Product Change Notification

Product Change Notification: E-16-014615

General Product Description:
AMPMODU MTE HEADERS GPL 296

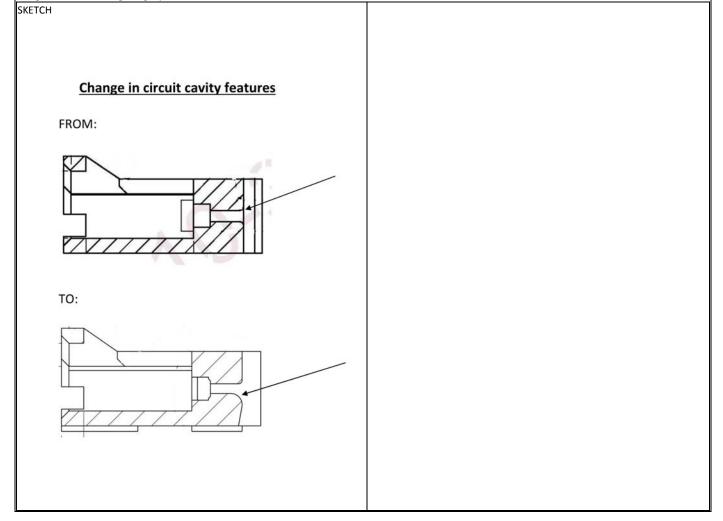
To satisfy customer demand for the capability of MTE headers to handle RoHS solder temperatures, TE Connectivity has retooled the MTE header product line to use high temperature compatible LCP molding material. These changes will result in the following product changes: 1) Housing material will change from high temperature nylon to LCP. 2) The header housing width will be reduced by 0.005 inches to accommodate the assembly process. 3) In order to consolidate some housing features, the contact cavity configuration will be changed slightly as shown in the attached sketch.
